Haweswater Aqueduct Resilience Programme - Proposed Marl Hill Section

Supplementary Environmental Information Report

Project No: B27070CT
Document Title: Proposed Marl Hill Section
Supplementary Environmental Information Report
Document Ref.: RVBC-MH_SEI
Revision: 0
Date: January 2022
Client Name: United Utilities Water Ltd

Illustration 2: Indicative appearance and vertical elevations of temporary bridge structures

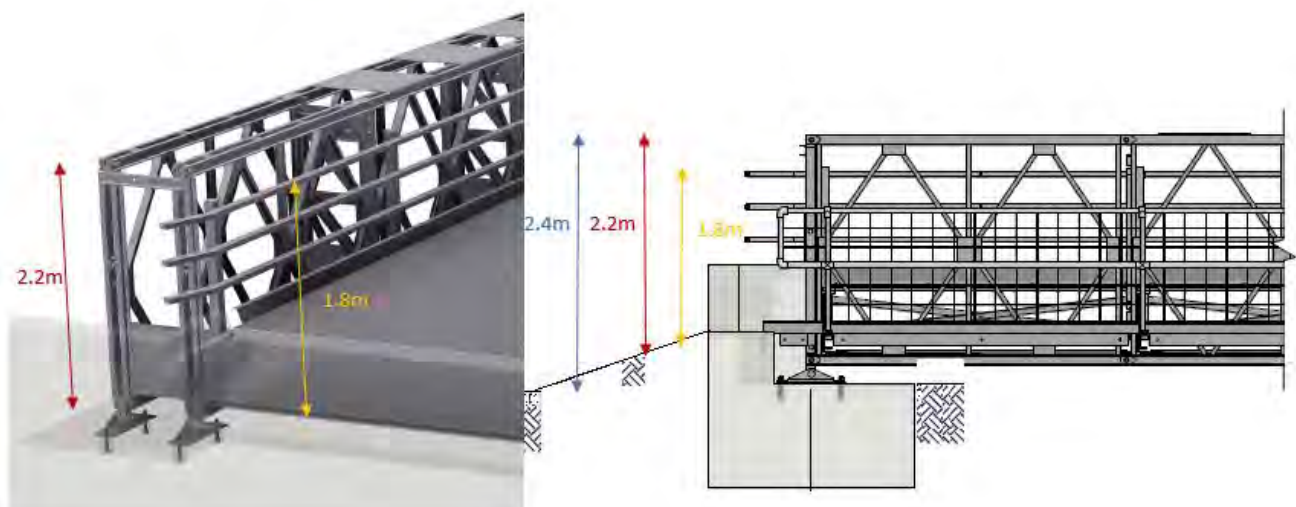
24) Following submission of the June 2021 planning application, it was decided to install a total of five temporary bridge structures (commonly referred to as '*Bailey bridges*') across the culverts along the proposed access track. At two out of five of these locations (referred to as Bridge A and Bridge B), it has been necessary to extend the planning application boundary by a short distance (less than 10 m to the north and south) to provide additional working room to install temporary bridge structures. The planning application boundaries have therefore been amended accordingly at these locations. The purpose of the proposed temporary bridging structures is twofold:

Illustration 3: Braddup Compound - Indicative Use of Temporary Bridges on Access Track

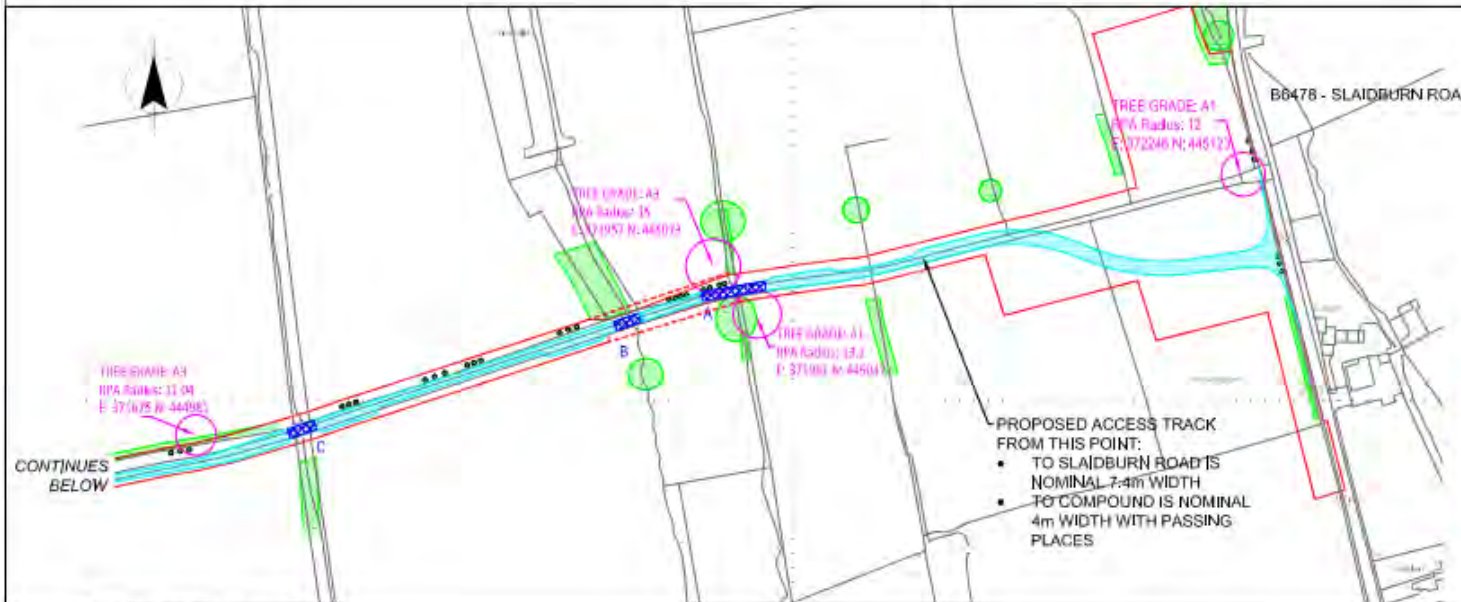
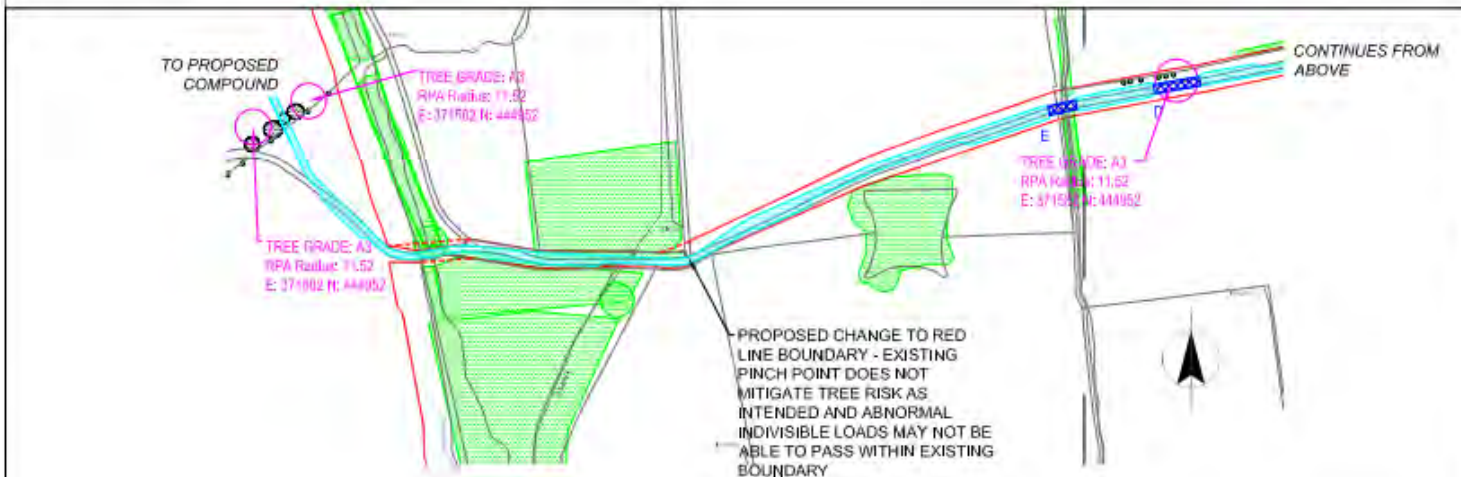
- To protect the root zones of Grade A trees situated adjacent to the track.
- 25) Temporary bridges C, D and E would be delivered within the existing (June 2021) planning application boundary.

- 27) The proposed locations of the temporary bridges A-E along the Braddup Compound access track, the root protection areas of Grade A trees and the associated amendments to the planning application boundary, are shown in Illustration 3.

- 28) In addition to the proposed planning application boundary changes to accommodate Bridge A and Bridge B, two very minor amendments are also proposed at ‘pinch point’ locations on the access track towards the core construction compound. These locations are also shown on Illustration 3. The proposed amendments comprise increasing the width of the access track slightly, to enable the safer passage of construction vehicles to and from the compound. Additionally, at one of the two ‘pinch point’ locations, the June 2021 planning application boundary did not optimise embedded mitigation to protect trees, and abnormal indivisible loads may not have been able to pass within the boundary.

FIGURE 1.2

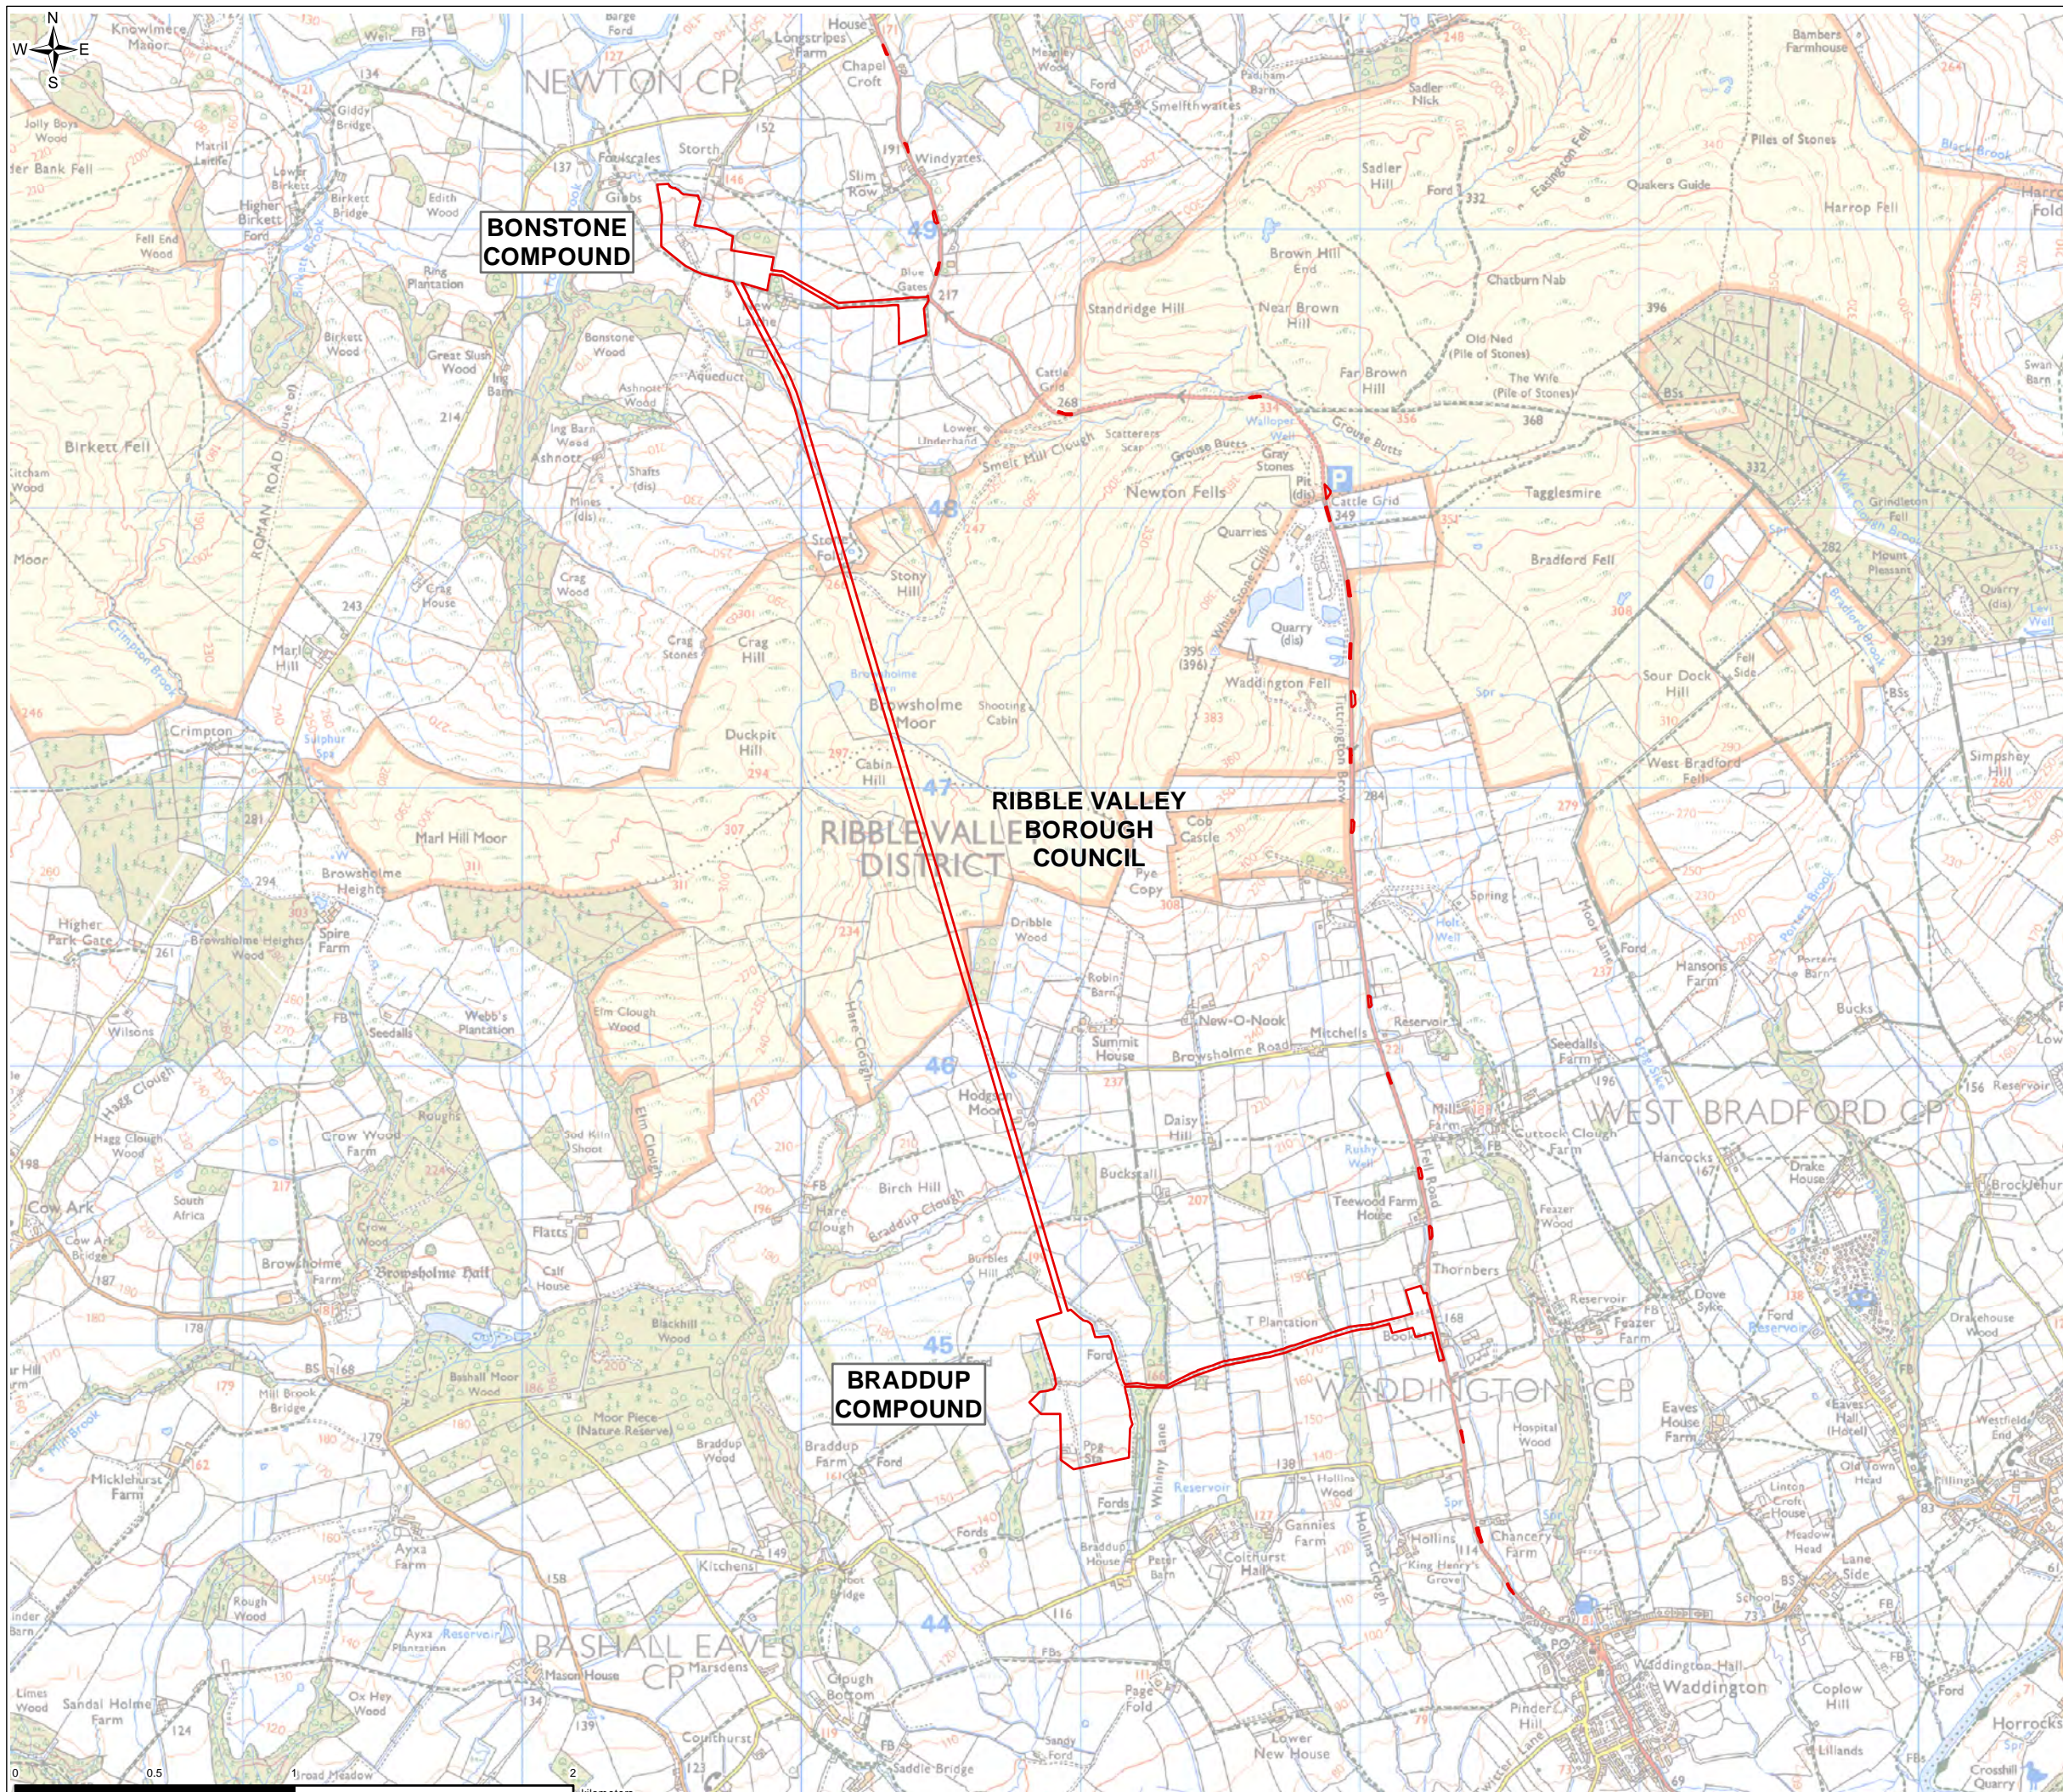
the main construction compounds is shown on Figure 1.2, with greater detail provided in the revised planning applications drawings. There are a few settlements within 3 km of the Proposed Marl Hill Section, the nearest being Newton-in-Bowland to the north and Waddington to the south. There are dispersed residential properties and farmsteads located throughout the area north of Waddington.
